European Network of Transmission System Operators for Electricity

Consultation on all Continental Europe TSOs' proposal for the definition of a minimum activation time period required for LER to remain available during alert state in accordance with Article 156(11) of the SO GL

1 October 2021

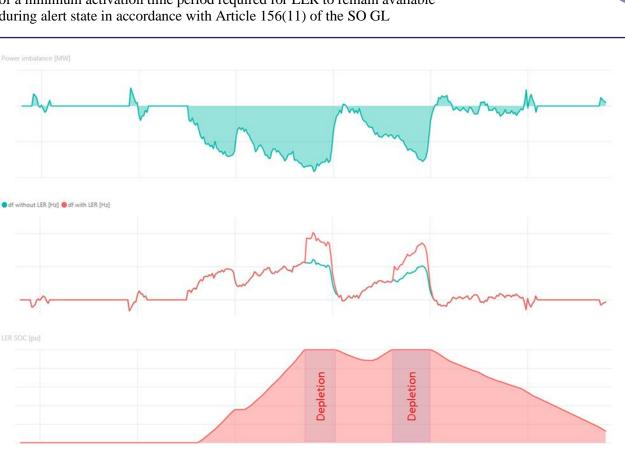
According to the analysis provided by the TSOs, only a small cost difference of about 10% was the result for different scenarios and activation periods. Considering the number of assumptions made to derive this result and the uncertainties behind them as well as the generation of stranded costs and value destruction related to the LER units that won't be able to fulfil this new requirement, we disagree that a TLER of 30 minutes clearly supersedes the 15min TLER.

The critical assumption is that the FCR demand increases proportionally to the growth of storage capacity when a storage capacity of 900 MW is reached. As this point, the TSOs assume that additional storage capacities of 1200 MW (for TLER 15 min) or 300 MW (for TLER 30min) do not replace conventional plants but will result in an increase of FCR demand of the same size. It is unclear to us why additional storage capacity should not have an effect at all.

Furthermore, in a situation with LER installations only, the FCR demand is assumed to be 4800 MW (for TLER 15 min) and 3500 MW (for TLER 30 min), respectively. In parallel, TSOs argue that the amount of energy required is the driver for additional FCR capacities in these cases. It is unclear to us, how 1200 MWh for TLER 15 min correspond to 1750 MWh for TLER 30 min.

## The reason of such a counterintuitive behavior can be explained as follows.

The simulated frequency deviation is derived from the input power imbalance assuming a certain MW/Hz curve representing the primary response behavior of the synchronous area.
